Official Transcript of Proceedings NUCLEAR REGULATORY COMMISSION

Title: Advisory Committee on Reactor Safeguards

Plant License Renewal Subcommittee

Date: Thursday, March 23, 2017

XI.M31: Reactor Vessel Materials Surveillance Program Surveillance Program – Plant A

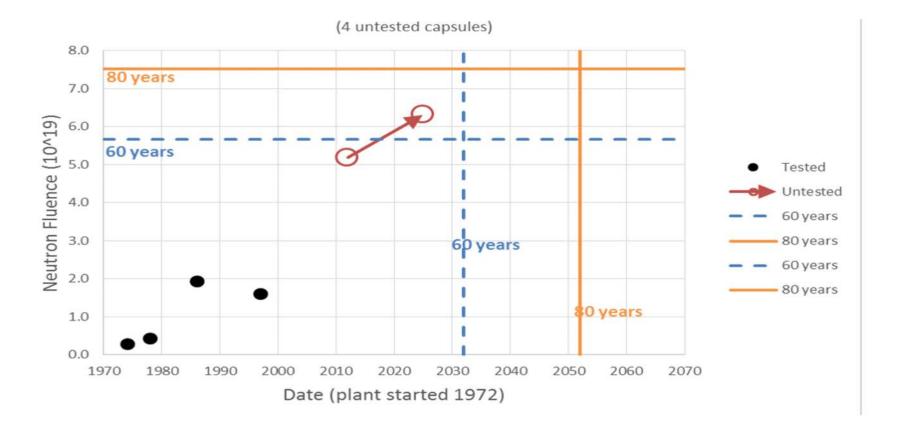
Next slide. And what I'll do the next two slides is just show two examples and what's illustrated here is the capsules for a plant. Five capsules have been tested, they're indicated by the filled circles. There is one untested capsule for this plant.

Now the, what's shown on the chart is neutron fluence on the Y axis and the date on the X axis. Plant started operation in this case in 1969. As you can see, every, what, ten, fifteen years, they pulled a capsule. So they have a very consistent tracking of the material performance, both as a function of fluence and also as a

Now, what I've shown in orange solid lines are the neutron fluence and the time frame at which the plant would hit 80 years of operation. The blue dash lines represent 60 years. So you can see the fifth data point that was roughly ten years ago, little less than ten years ago, provides the data needed for the 60-year fluences.

Now, the one untested capsule in this case is, I believe, today still in the vessel. But the licensee plans to withdraw it when it exceeds the 80-year fluence. So that would enable it then to have a data point that meets the 80-year fluence requirement. That is not a part of their current program, a part of their, if you will, Appendix H surveillance program.

But it's a spare capsule that they have that's available to them. So in this case, I would say this plant has a very good program from the perspective of the number of capsules first of all, the spacing of the data, and the ability to test a capsule to achieve the 80-year fluence. Next slide.
